GEMINI PROJECT

EA Application: Response to Secondary Information Request

MAGNETIC SOUTH

AUGUST 2021

Figure 7: Regulated Vegetation (Of Concern Regional Ecosystem (RE))

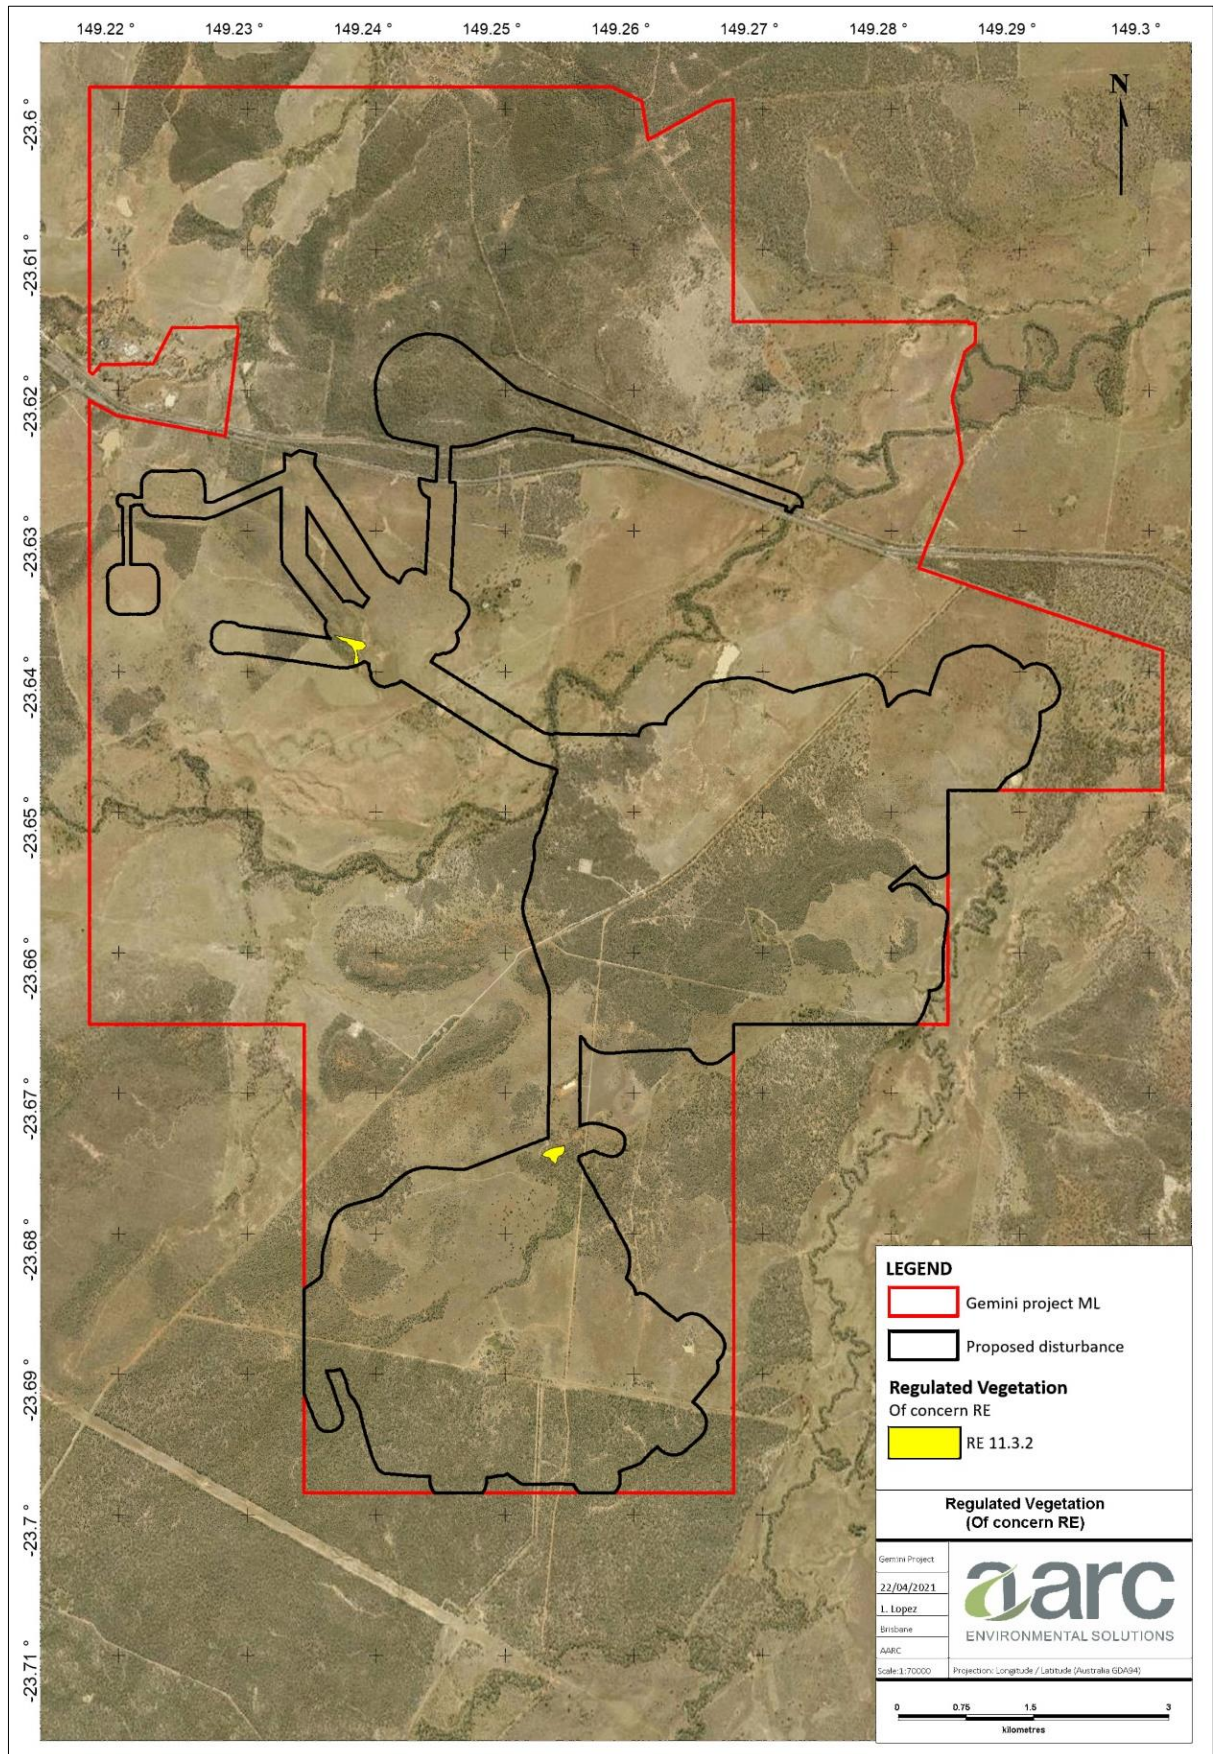
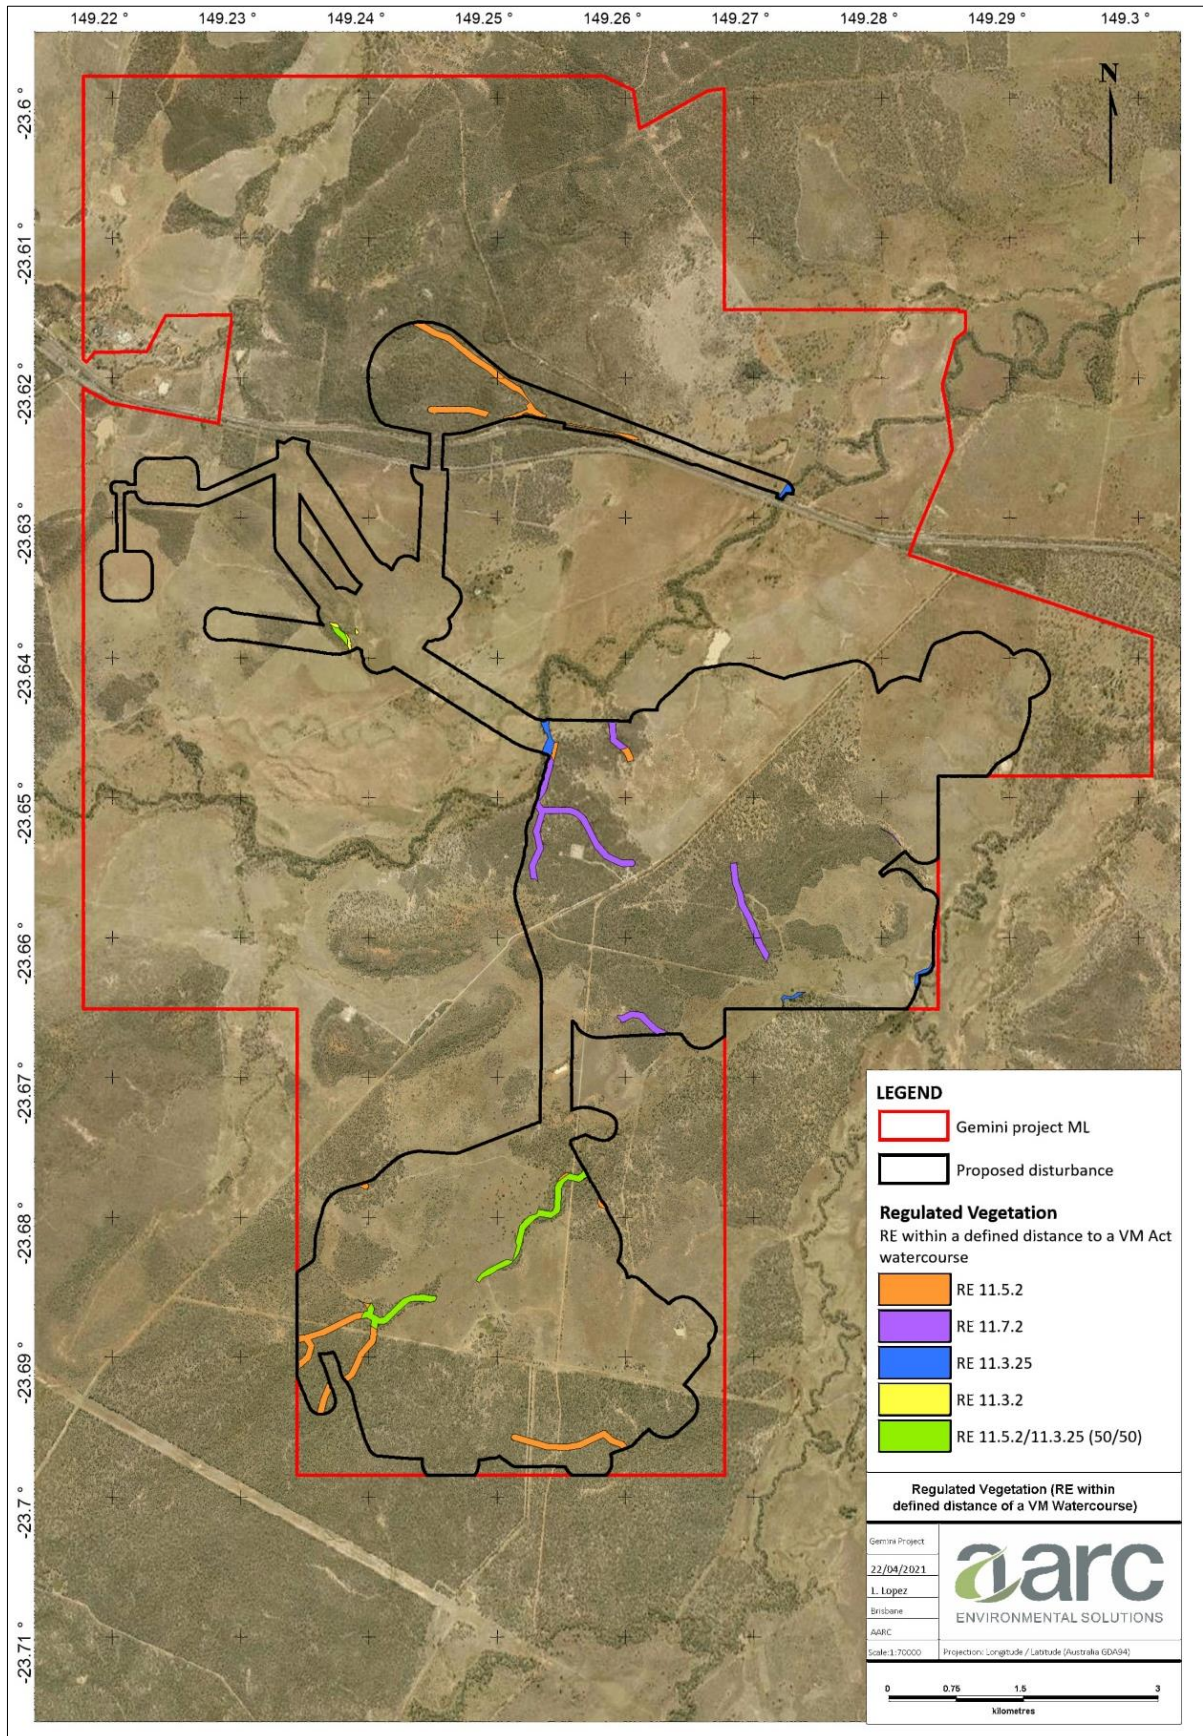
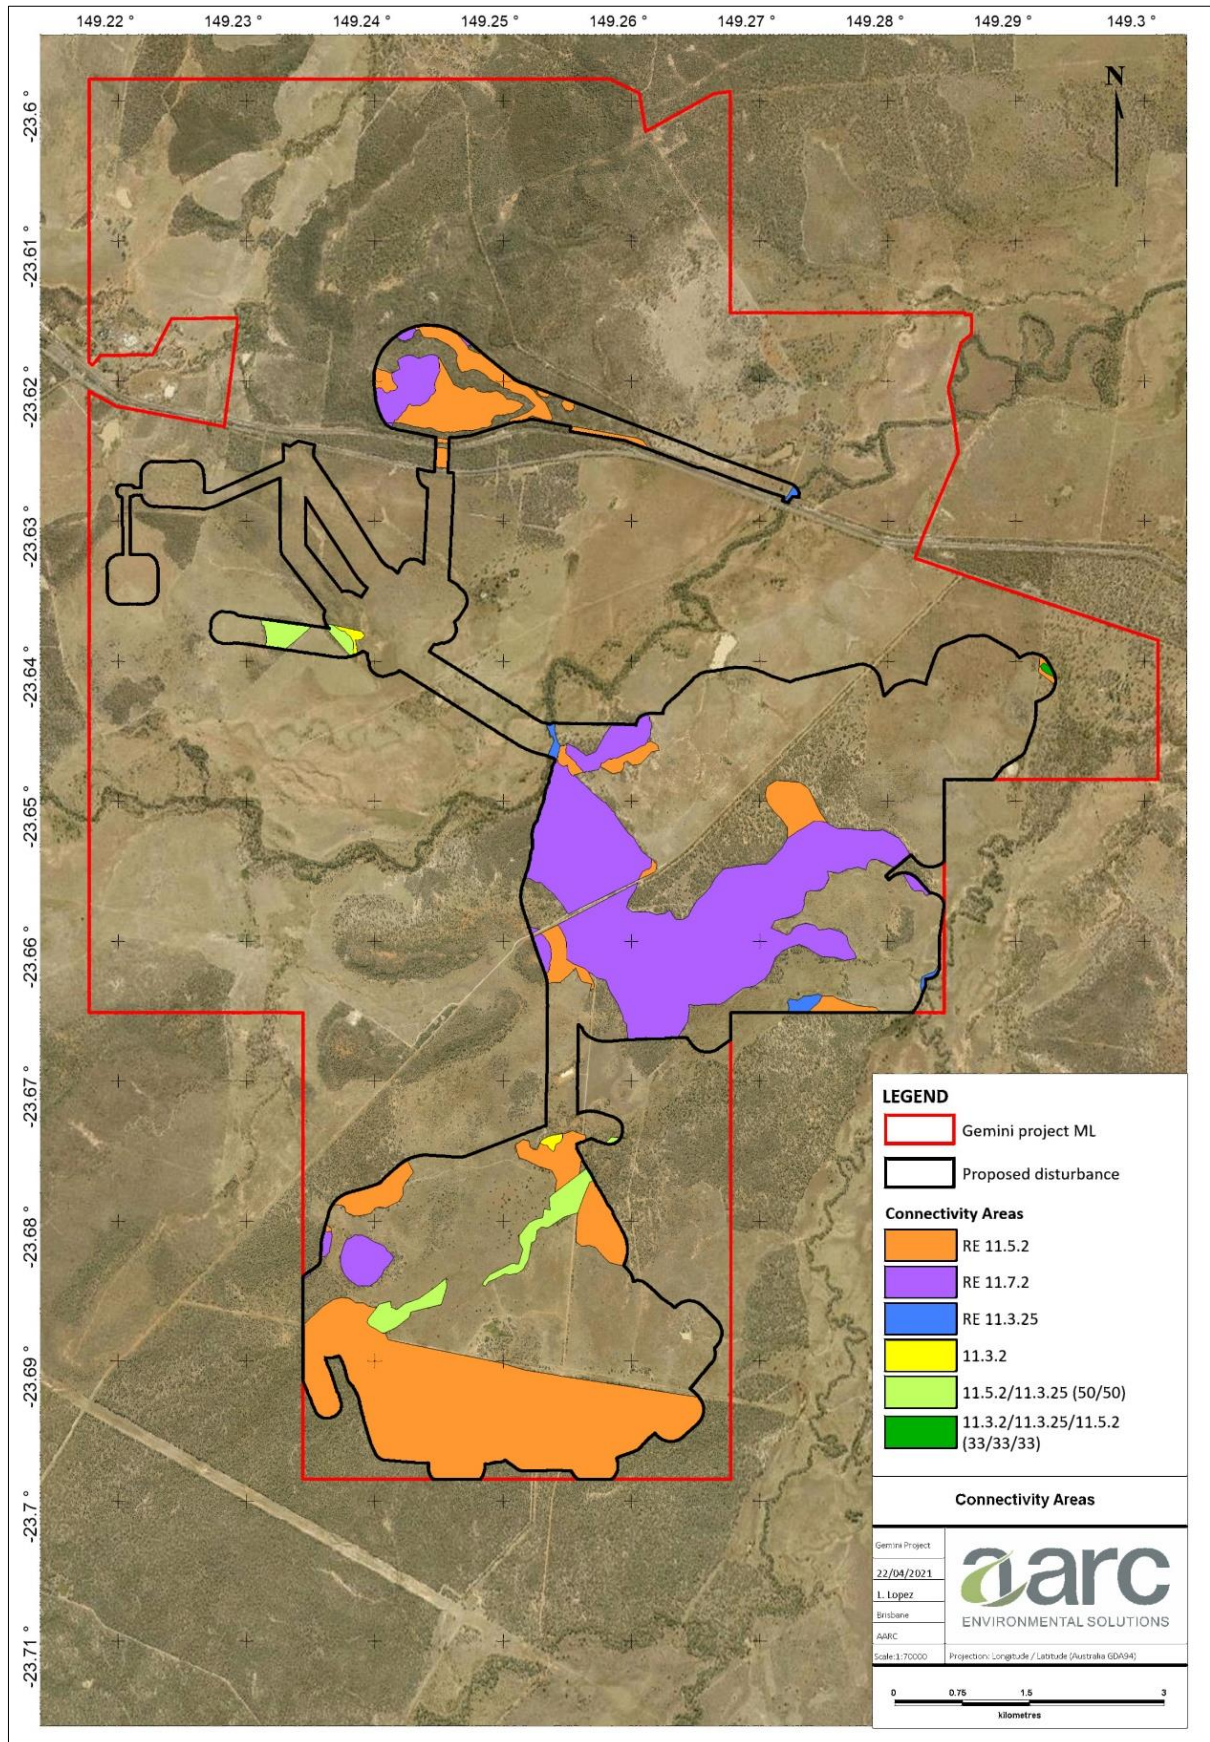
As per the mining guideline for Model Mining Conditions (ESR/2016/1936, Version 6.02, Effective 07 Mar 17) for Impacts to Prescribed Environmental Matters, provide the location of impact and area (ha) of maximum extent of impact for each regional ecosystem (RE) within the prescribed environmental matters for regulated vegetation and connectivity areas. For the location of impact, multiple figures that reference only the areas of the prescribed environmental matters that are being impacted by the resource activity, is preferable.

A revised Table H2 has been prepared providing a breakdown of the area of each regional ecosystem (RE) for each of the Prescribed Environmental Matters (Table 5).

Figure 10: Annual distribution of winds at the Project site predicted by TAPM/CALMET

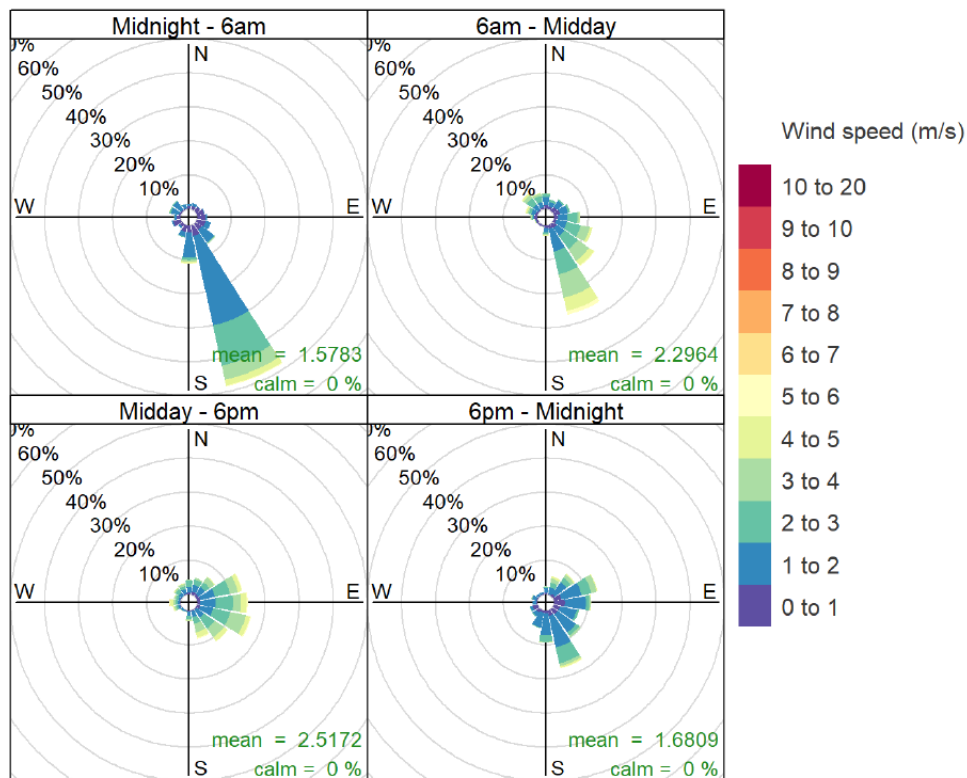
It is noted from Section 3.3.3.2.1 of Appendix L that air quality data from Department of Environment and Science (the department) monitoring station in Blackwater has been used to provide ambient background concentrations. Section 9.2.3.1 of Revised Supporting Information states that data from the department's monitoring station in Blackwater adequately accounts for potential cumulative contributions from surrounding industry, including Bluff Coal Mine. Bluff Coal Mine is 12 kilometres (km) from Gemini Project. Blackwater is located a further 23km west of Bluff Coal Mine, i.e., a total of 35 km from Gemini Project. Ambient background concentrations measured at Blackwater would, therefore, not be representative of the ambient air quality at Gemini, which is a lot closer to Bluff, for example, than Bluff is to Blackwater. Gemini Project is also located in a different direction from Bluff than Blackwater, and therefore, ambient air quality as influenced by prevailing winds, for example, would be quite different.

The Bluff Coal Mine is located approximately 11km to the west of the Project site. As detailed in Appendix A of the AQGGA and shown in Figure 10 and Figure 11 of this report, the meteorological data for the Gemini Project illustrates that winds occur infrequently from the west (less than 8% of the time).
